Authorized Field Change

AFC 12917

Subject: Deaeration Tank Hose Re-Route

Engine Family: MaxxForce[®] 11 and 13

Figure 1. High Temperature Radiator.

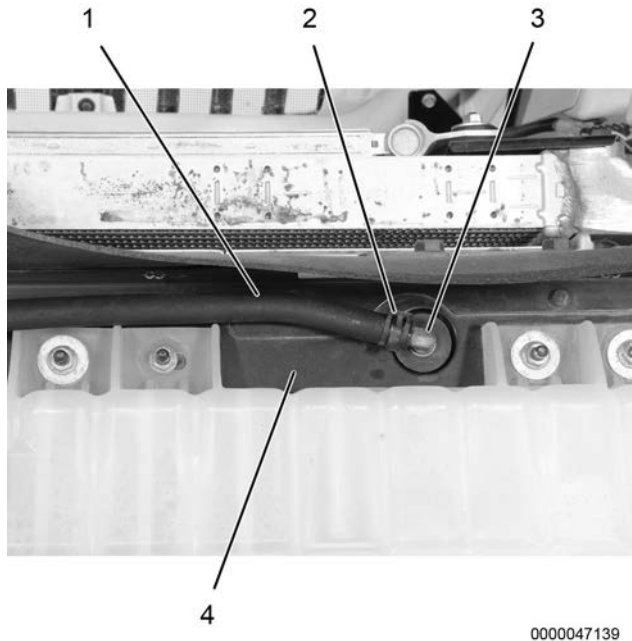
1. Hose
 2. Clamp
 3. Fitting
 4. High temperature radiator
8. Remove clamp (Figure 1, Item 2) and hose (Figure 1, Item 1) from fitting (Figure 1, Item 3) located on top of high temperature radiator (Figure 1, Item 4).

Figure 2. Coolant Pipe Assembly.

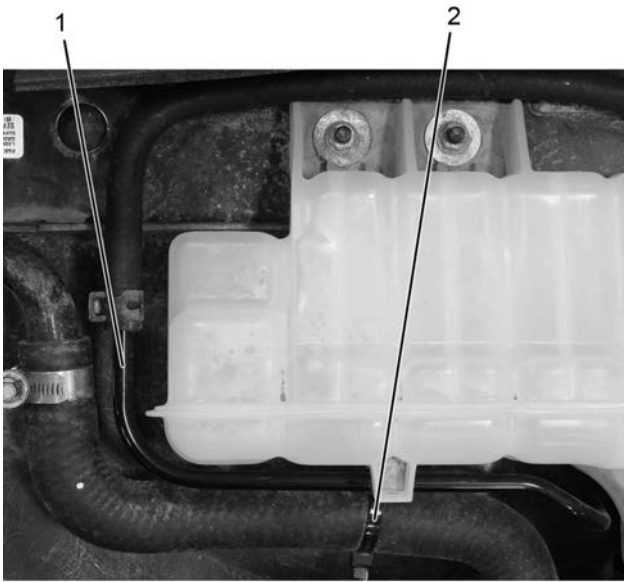
9. Remove cable tie strap from push pin (Figure 2, Item 2) securing coolant pipe (Figure 2, Item 1) to coolant hose and deaeration tank.

Figure 3. Coolant Pipe.

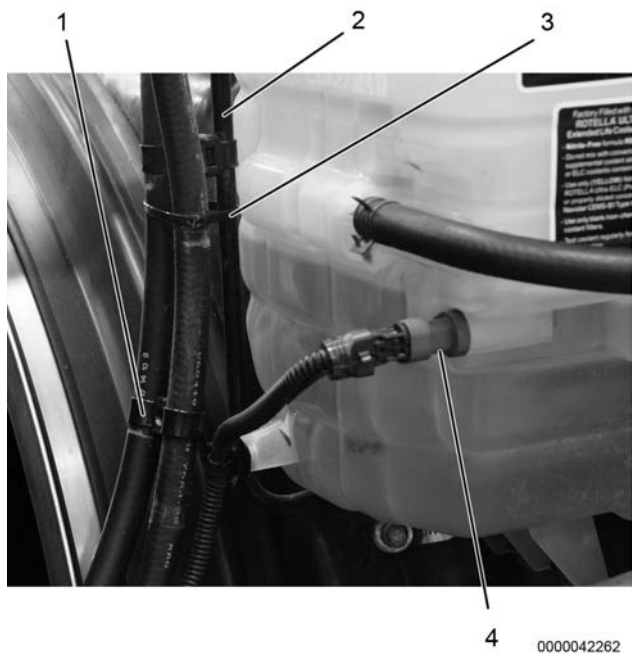
10. Remove push pin (Figure 3, Item 1) and cable tie strap (Figure 3, Item 3) securing coolant pipe (Figure 3, Item 2) to deaeration tank.

Figure 4. Hose and Clamp Assembly.

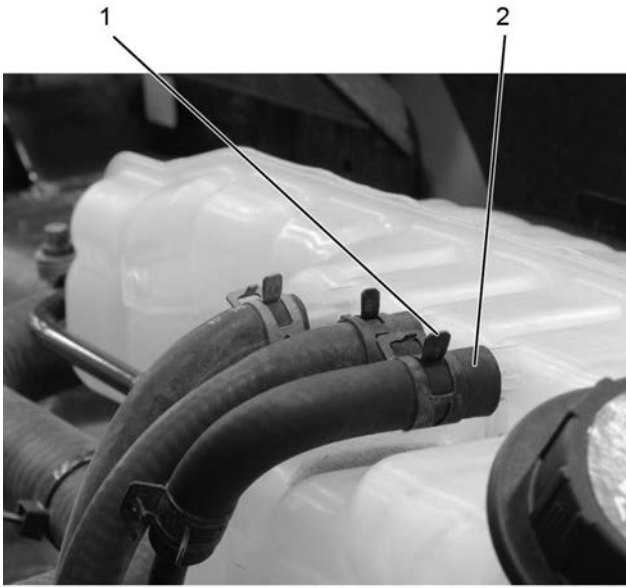
11. Remove clamp (Figure 4, Item 1) securing hose (Figure 4, Item 2) to deaeration tank. Discard clamp, hose, and coolant pipe.
12. After discarding coolant pipe, restore tie straps and push pin.

Figure 5. Cap and Clamp Assembly.

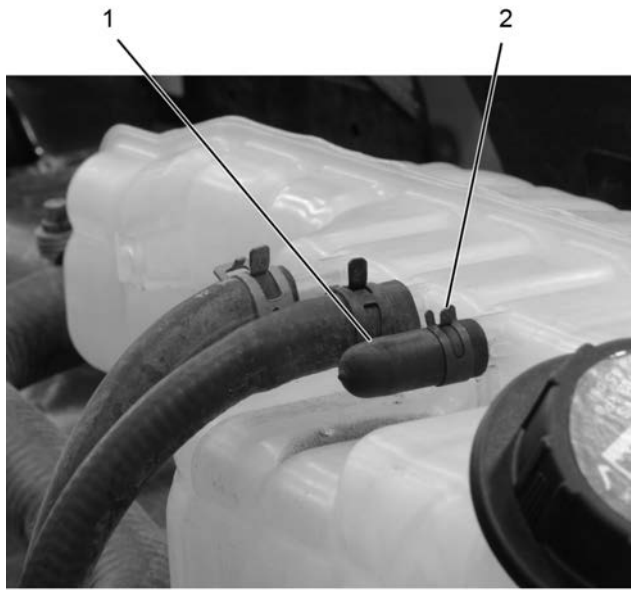
13. Install cap (Figure 5, Item 1) and clamp (Figure 5, Item 2) supplied with kit. Do not reuse old clamp.

Figure 6. Low Temperature Radiator Connections.

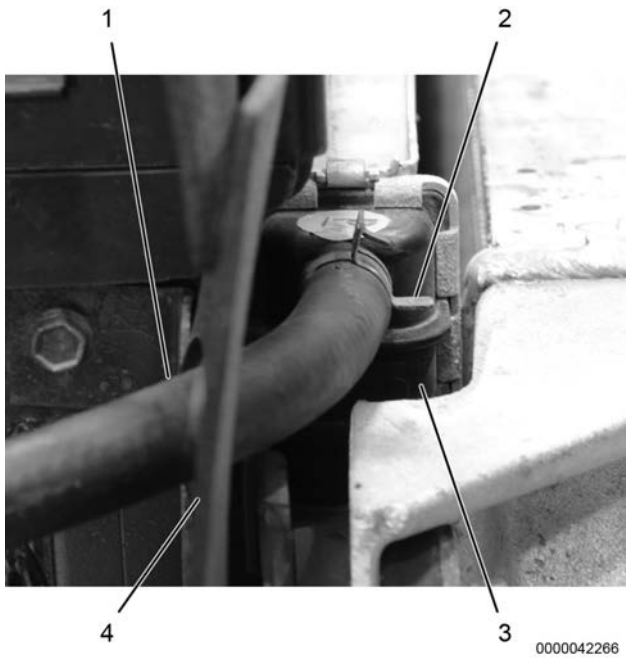
14. Remove clamp (Figure 6, Item 2) and hose (Figure 6, Item 1) from low temperature radiator (Figure 6, Item 3).

Figure 7. Hose and Clamp Assembly.

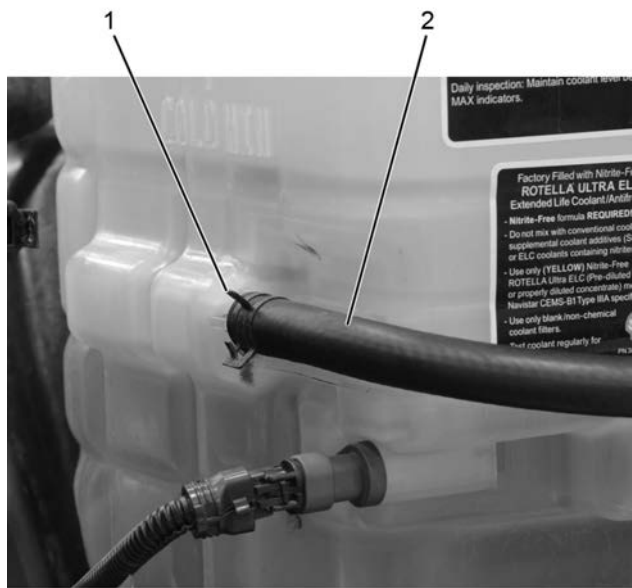
15. Remove clamp (Figure 7, Item 1) and hose (Figure 7, Item 2) from back of deaeration tank. Discard hose.

Figure 8. Single Formed Hose Assembly.

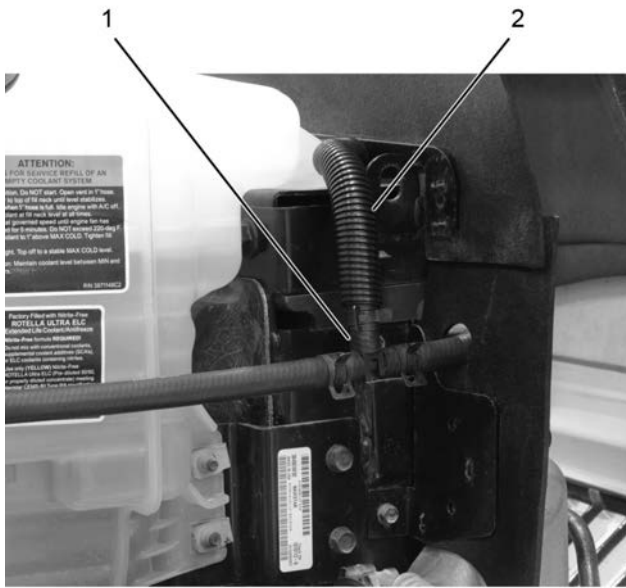
16. Insert end of formed T-hose through recirculation seal (refer to Figure 8). Clamp may need to be removed.
17. Install formed T-hose and clamp on low temperature radiator (refer to Figure 6).

Figure 9. High Temperature Radiator Connections.

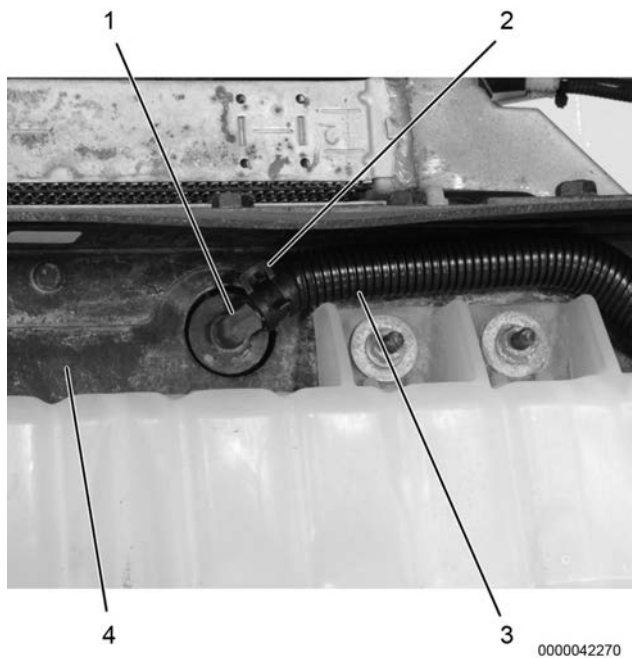
18. Turn fitting (Figure 9, Item 1) on top of high temperature radiator (Figure 9, Item 4) to align with single formed hose fitting end (Figure 9, Item 3).
19. Install tee end (Figure 8, Item 1) of single formed hose (Figure 8, Item 2) to fitting on top of high temperature radiator.
20. Install hose and clamp onto fitting on back of deaeration tank.
21. Install coolant previously removed using Coolant Management Tool.

Figure 10. Deaeration Tank.

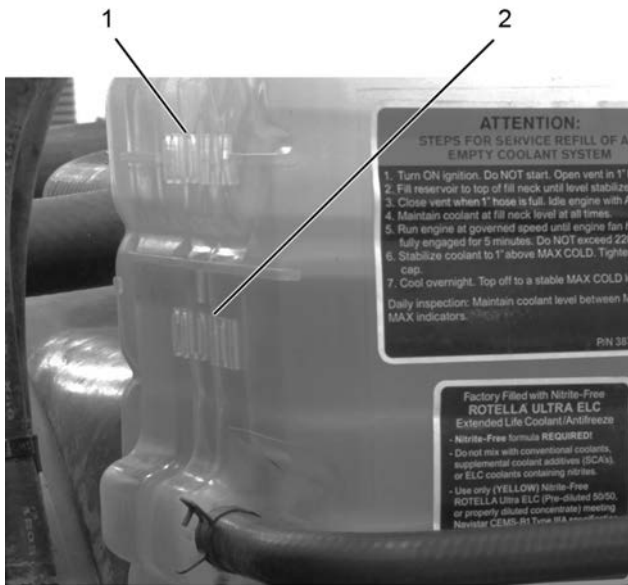
22. Measure distance between MIN line (Figure 10, Item 2) and MAX line (Figure 10, Item 1) on deaeration tank.

Figure 11. Deaeration Tank Sticker.

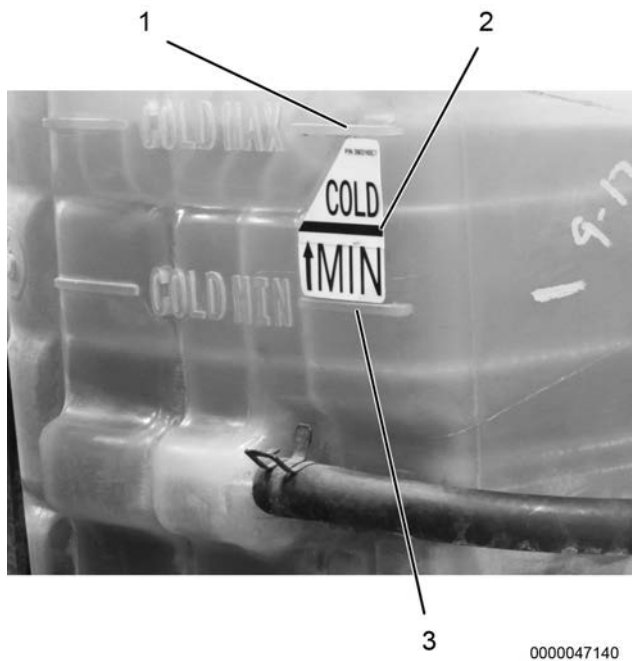
1. MAX line
 2. New MIN line sticker
 3. Old MIN line
- a. If distance measures approximately 2 in (5 cm), clean surface of deaeration tank of any oil or road debris, and install new MIN line sticker (Figure 11, Item 2).

- b. If distance measures approximately 1.25 in (3.2 cm), installation of new sticker is not required.
23. Start engine to verify proper operation, and no leaks or fault codes are present.
